P 530261

**ON-SITE SEWAGE DISPOSAL SYSTEM
 HOWARD COUNTY HEALTH DEPARTMENT
 BUREAU OF ENVIRONMENTAL HEALTH**

SUBDIVISION: McKendree View LOT NUMBER: 8

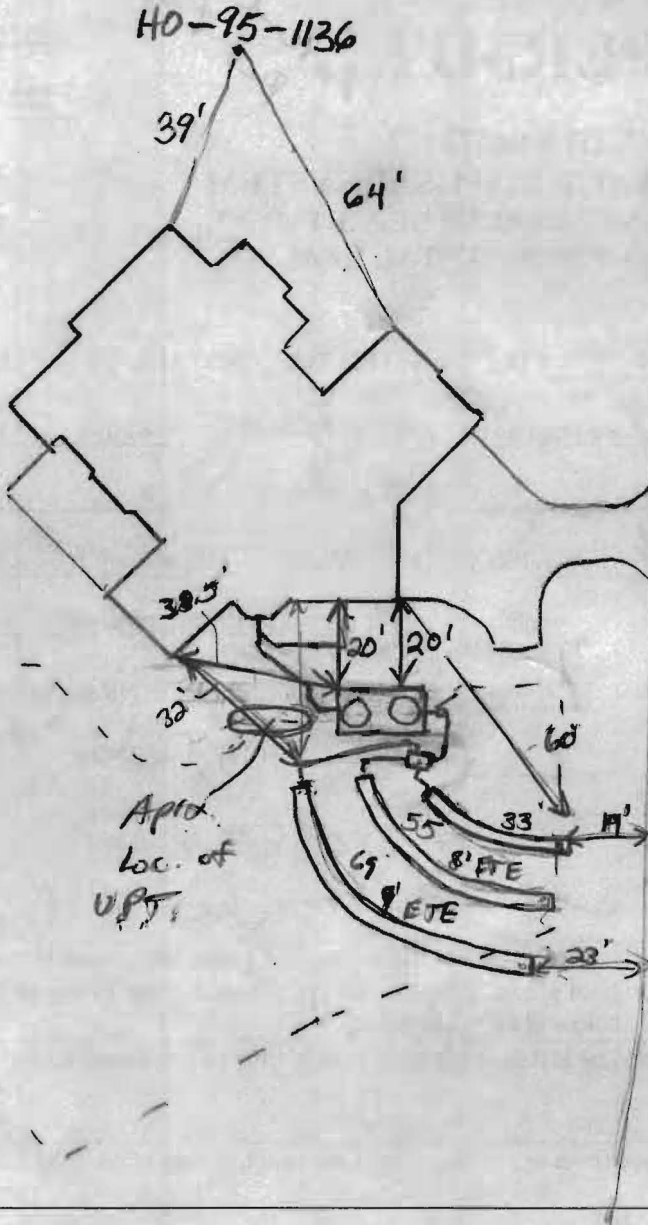
PRE-CONSTRUCTION
 12/29/08 Told contractor to cut tank a little further down the road as shown on Approval

BP plan. SDA point to be staked. Porpoise Tank may need to be moved on BP for this was removed. one to failure. Call for trench layout w/ septic area is staked (150) 2/13/09. Install 3 short trenches across the highest usable part of the easement. Knoll gets worse as you go downhill. Trench lengths 35', 33' and 68'. Tank already set. Could have kept it closer to garage. Keep box and trench lines close to tank but on solid ground. See location on B.P. plan (150) 2/17/09 System installed as installed. OK to back fill. (150)
